**ANGEL PLACE  
LEVEL 8, 123 PITT STREET  
SYDNEY NSW 2000**

## **SECTION 4.55(1A) MODIFICATION APPLICATION - SSD-10375 PITT STREET NORTH OVER STATION DEVELOPMENT**

This section 4.55(1A) Modification Application has been prepared on behalf of Pitt Street Developer North Pty Ltd (**the Applicant**) to amend SSD-10375 which applies to the Pitt Street North Over Station Development Stage 2 (**PSN OSD**) at 252 Pitt Street, Sydney.

Figure 5 CGI of proposed Northern Podium Façade

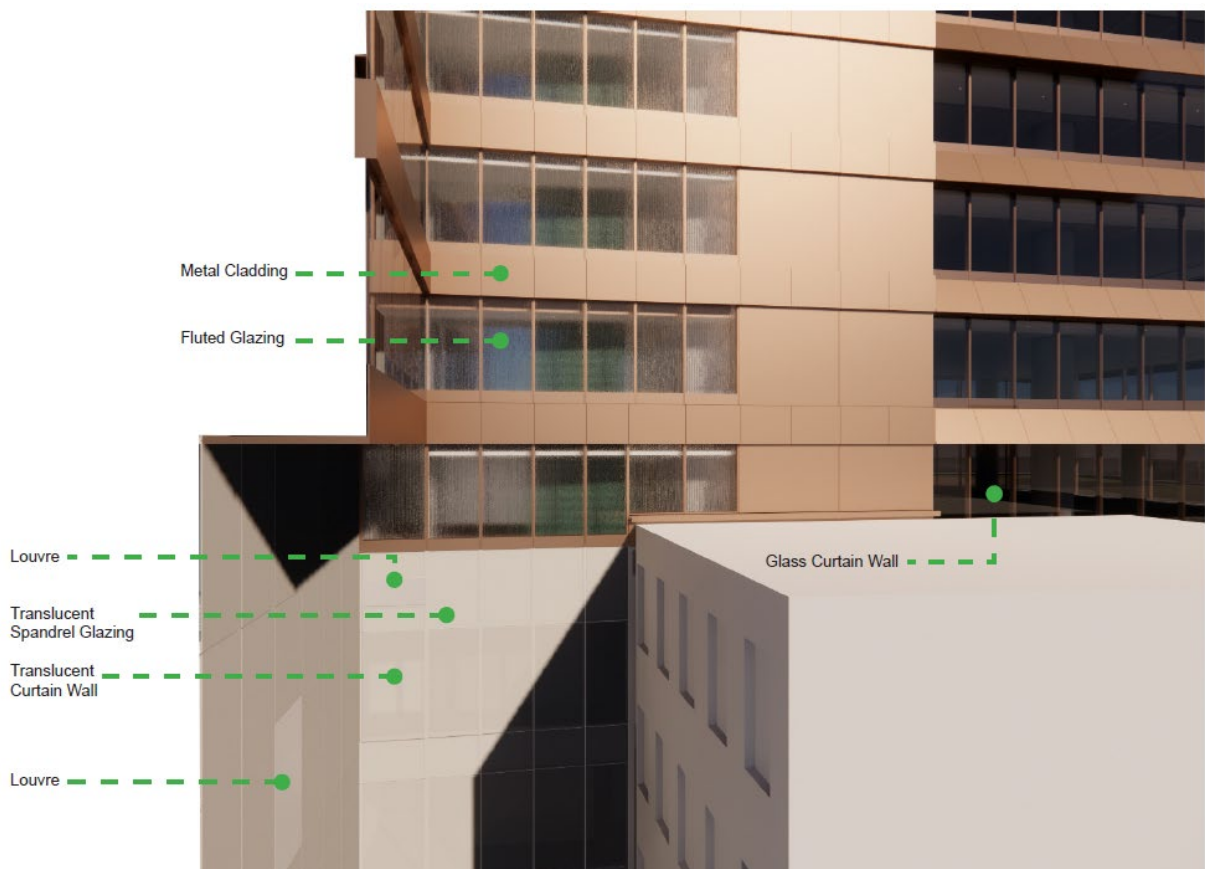
A clarification of the materials on the northern podium façade adjacent to the lightwells of the Masonic Building and Ashington Place is proposed. The white spandrel glazing on the columns has been clarified to be metal cladding and a correction has been made to the colouring on the SSD DA drawings differentiating between translucent curtain wall and white spandrel glazing.

The proposed modifications are illustrated in **Figure 4** and the computer generated image (CGI) at **Figure 5** and will result in the same visual appearance and reflective performance as those outlined in the SSD DA approval.

- an update to the level 11 terrace balustrade to a continuation of the translucent glazing below;
- a minor increase in the extent of the mechanical intake/ exhaust louvres; and
- clarification that the glazing adjacent to the amenities is fluted glazing as opposed to a glass curtain wall as noted on the SSD DA approval plans.

Figure 6 Proposed Modification to Northern Tower Façade

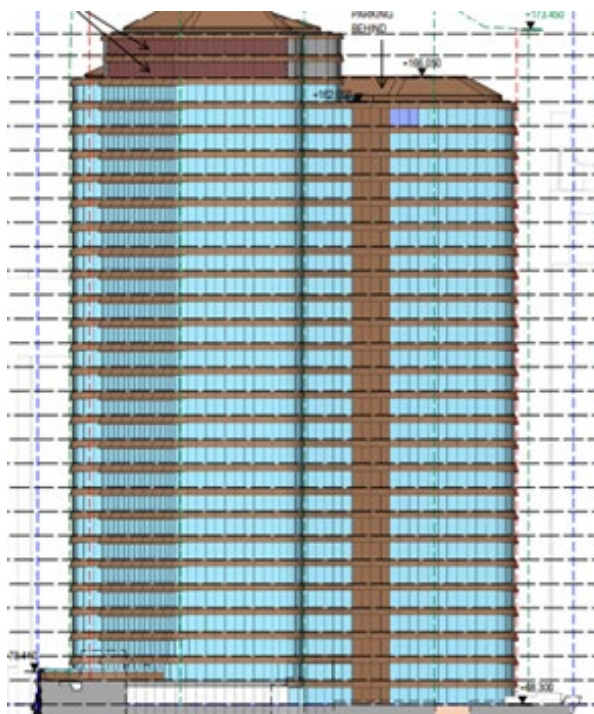
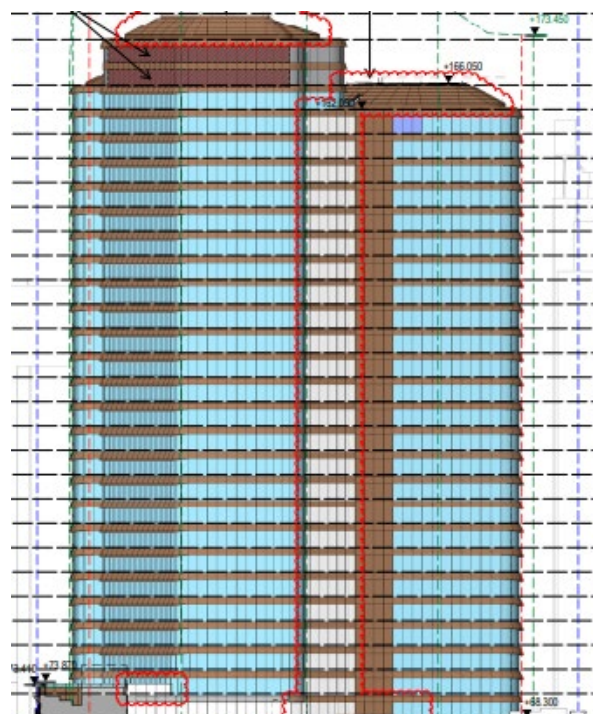
A correction has been made to the Northern Tower façade as illustrated in **Figure 9**. The approved plans show a glass curtain wall adjacent to the amenities and this has been corrected to fluted glass to provide required privacy. The materiality of this portion of the façade will have the same neutral colour and appearance as originally intended.

Figure 7 Correction to Eastern Podium Façades

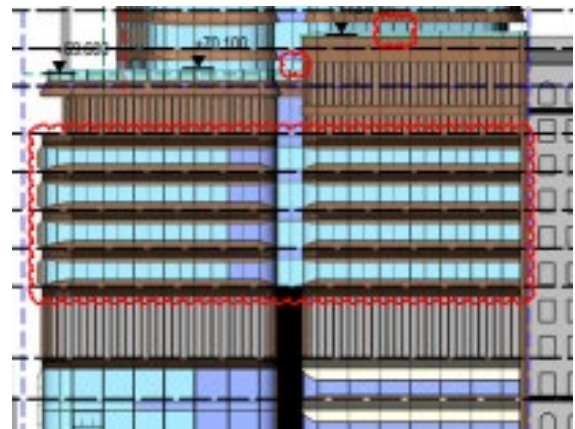
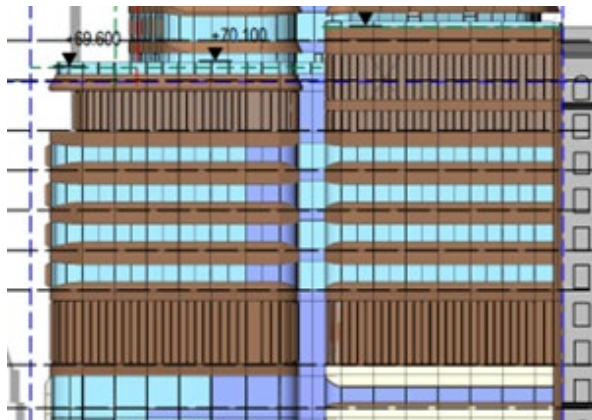
A correction has been made to the podium façade (level 5 through to level 9) on the eastern and western elevations to accurately show the corrugation detailing. This change is a graphical fix as illustrated in **Figure 7** and **Figure 8**.

The elevations of these facades have also been revised to reflect the change in terrace door opening widths as discussed further in **Section 2.3**.

Figure 9 Correction to Southern Tower Façade

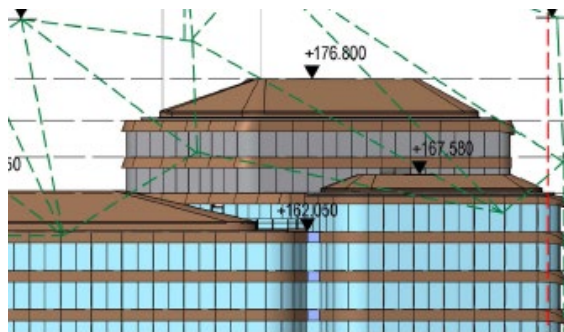
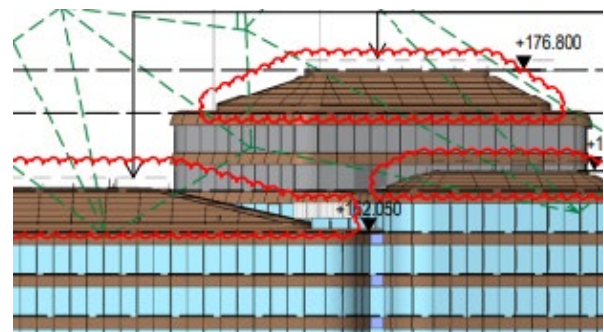
A correction has been made to the south western tower façade (level 35) to show fluted glazing adjacent to the amenities. A correction has also been made to the south western roof detailing, this change is a graphical fix as illustrated in **Figure 9**.

Figure 10 Approved General Arrangement Elevation West Elevation – Pitt Street (with missing north-south façade identified in red)

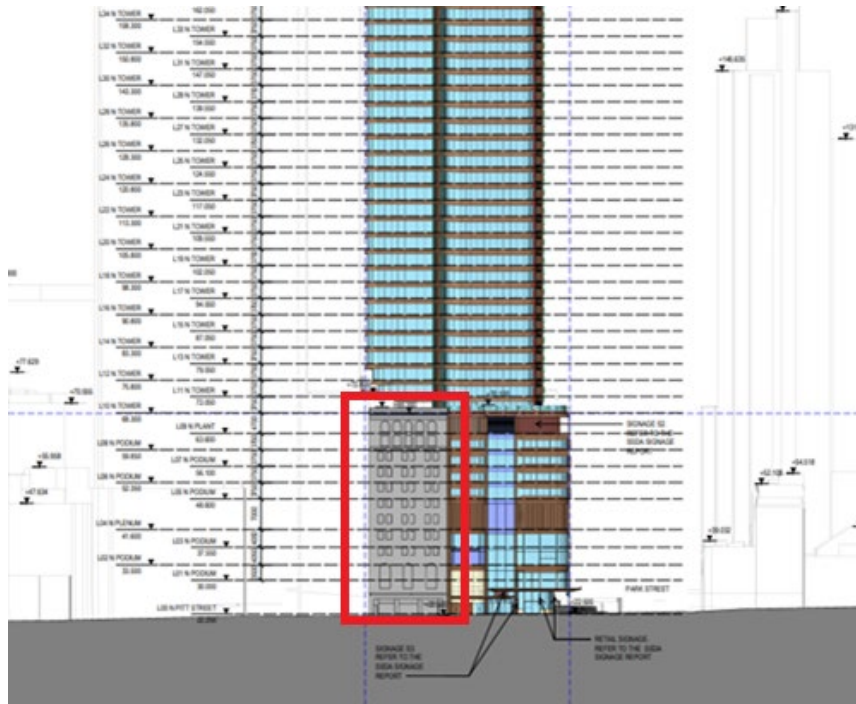
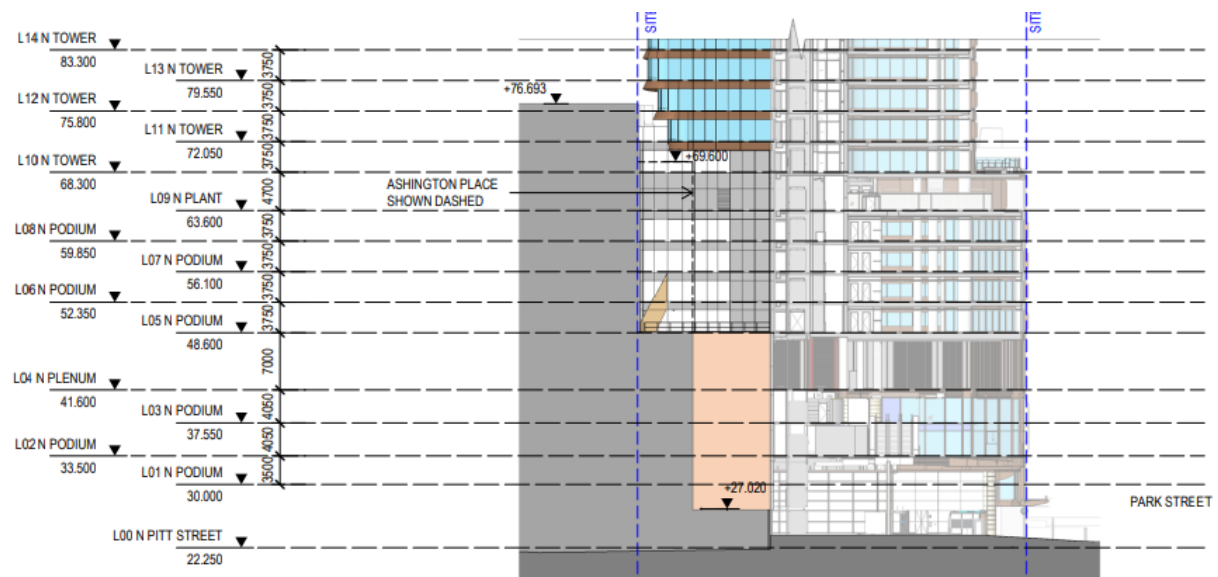
The north western façade of the OSD podium was obscured in the approved General Arrangement Elevation West Elevation - Pitt Street Plan (drawing SMCSWSPS-FOS-OSN-AT-DWG-960001) as illustrated in **Figure 10**.

As part of this modification application it is proposed to include an additional plan General Arrangement Elevation North Western Façade (North – South Section) (SMCSWSPS-COX-OSN-AT-DWG-960005) with details of the secondary western façade as illustrated in **Figure 11**.

The façade materiality consisting of a translucent curtain wall and white spandrel glazing is consistent with the design intent as per the Pitt Street North Design Guidelines and as outlined in the Architectural Design Report prepared by Foster + Partners accompanying the SSD DA submission.

Figure 12 Modification to Level 10 Terrace Openings

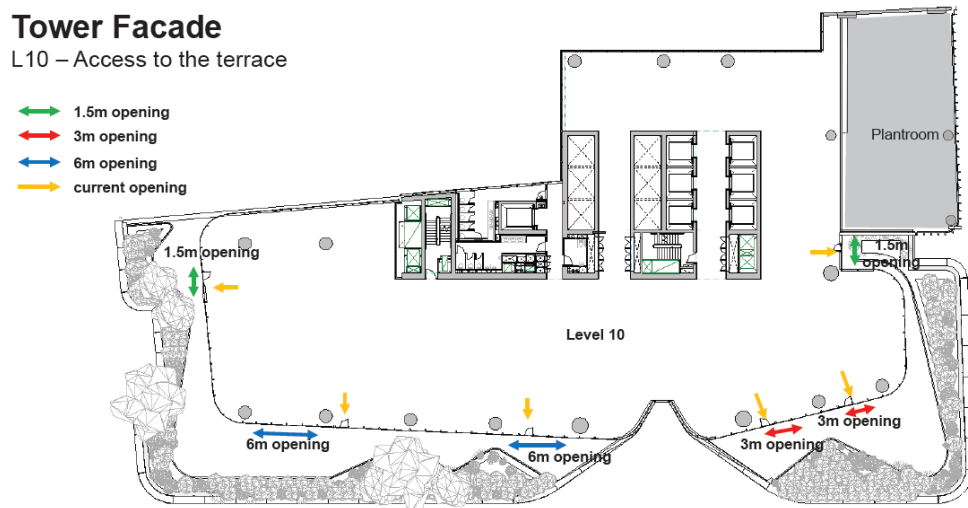
It is proposed to modify the Level 10 and Level 11 terrace door openings from single width swing doors to sliding doors of various widths as illustrated in **Figure 12** and **Figure 13**.

The modified door openings will improve the amenity of the tower including the usability of and access to the terrace areas. Both terraces have a 1.8m high glass balustrade around their perimeter to improve the usability of these spaces and the modified door openings will not be visible from the surrounding public domain.

Figure 15 Modification to Level 10 window transom

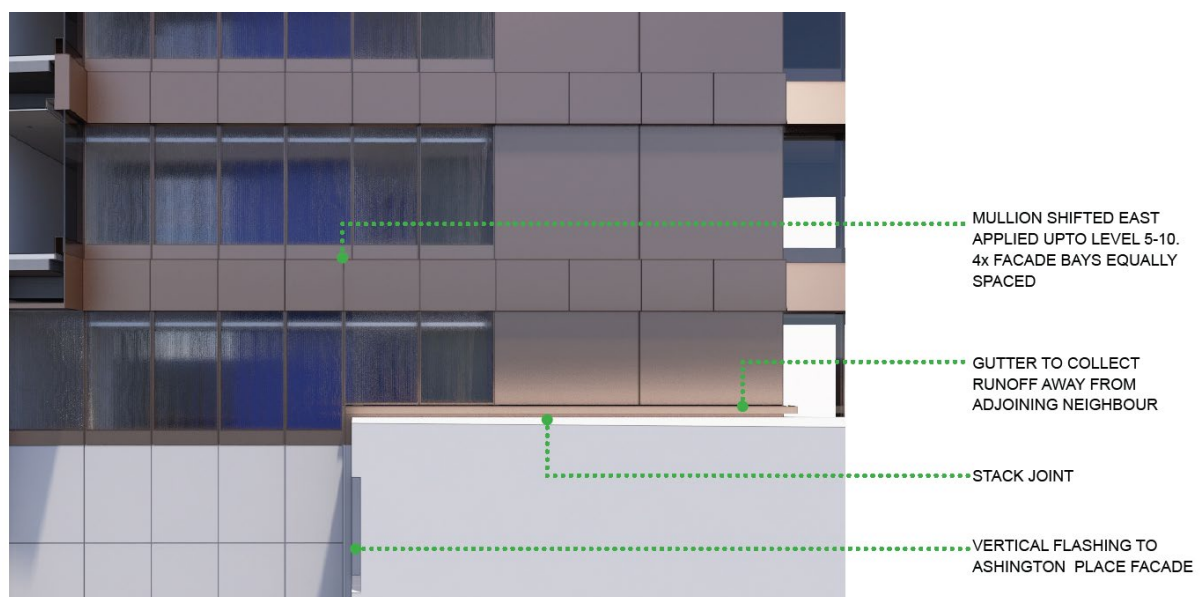
It is proposed to raise the Level 10 horizontal transom adjacent to Ashington Place to allow for adequate waterproofing structures between the two buildings. Currently the approved SSD DA plans show a full height curtain wall window in this location adjacent to the unfinished boundary wall of Ashington Place as illustrated in Picture 1 of **Figure 14**.

As illustrated Picture 2 of **Figure 14** and in Error! Reference source not found. the modification proposes a box gutter at the height of the adjacent building structure with curtain wall window above and block wall infill under the transom.

The proposed modification will not result in any fixture being secured to Ashington Place which protrudes into the PSN site. Sealant will be applied to prevent water seeping in between the PSN OSD and Ashington Place Structures.

In addition to aiding in constructability, the modification will result in an improved outlook from Level 10 of the OSD, prevent difficulties with maintaining windows in this location (cleaning etc) and will not be perceptible from the surrounding public domain.

Figure 16 Proposed Modification upper to tower levels

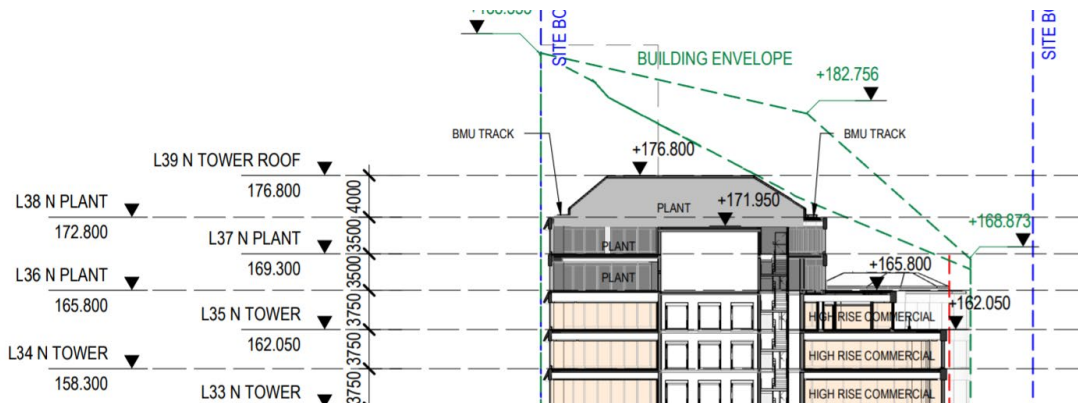
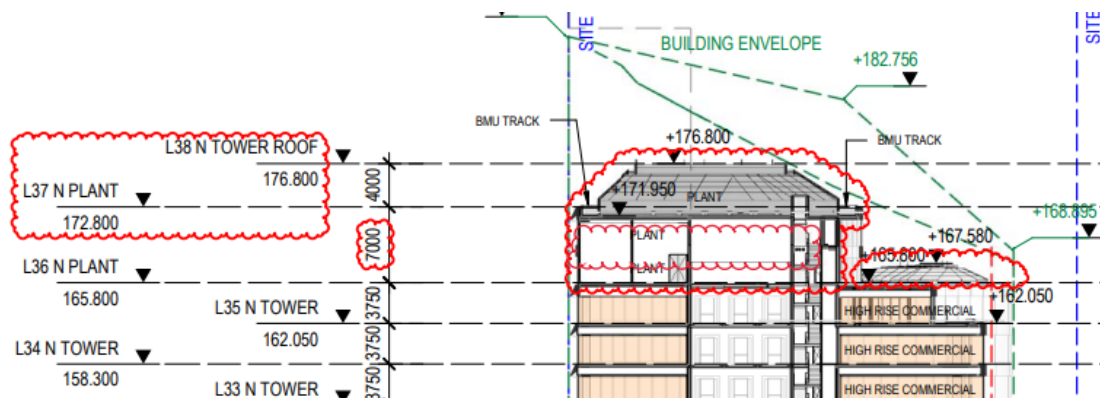
The Level 37 slab and plant rooms (detailed in SMCSWSPS-FOS-OSN-AT-DWG-933713) are proposed to be removed rendering this drawing sheet redundant. As illustrated in Section B-B in **Figure 16** this change results in a double level void but no external changes to the façade or height of the building.

As a consequence of removing the previous level 37, the upper levels of the tower and roof are renamed.

Figure 17 Axometric view of rooftop air terminals within concept envelope approved under SSD 8875

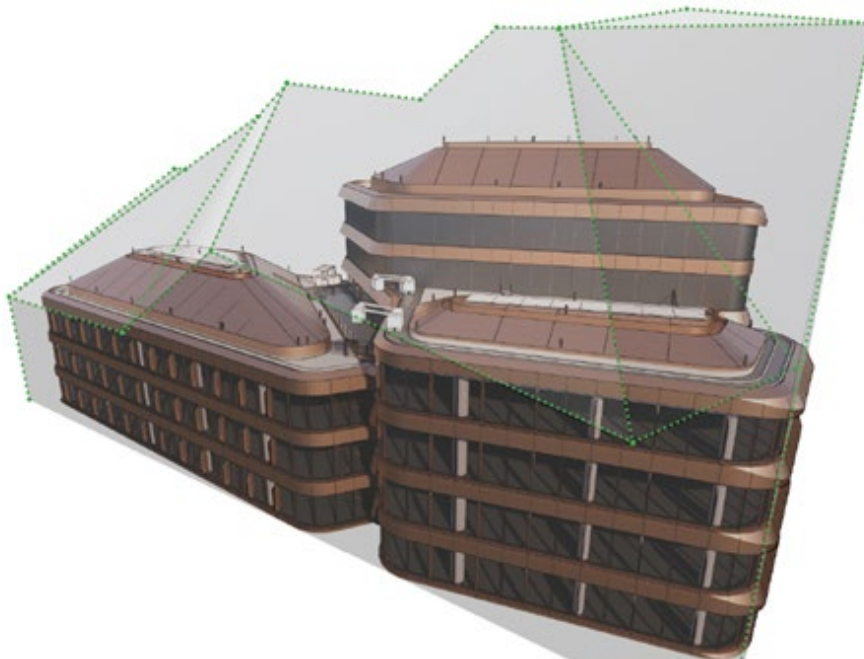
The air terminals will remain within the concept envelope approved under (SSD 8875) as illustrated in **Figure 17**, will be under the maximum height of controlled activities within the prescribed airspace for Sydney Airport (RL 189m AHD) and will have a very minor (if any) visual impact.

*B9. The maximum height of the approved building must not exceed RL 176.80 m AHD, including plant and lift overruns, communication devices, antennas, satellite dishes, masts, flagpoles, chimneys, flues and the like. **Air terminals may exceed the maximum building height but must not exceed RL 177.80 m AHD.** Details confirming compliance with this condition must be submitted to the Certifying Authority prior to the issue of the relevant Construction Certificate.*
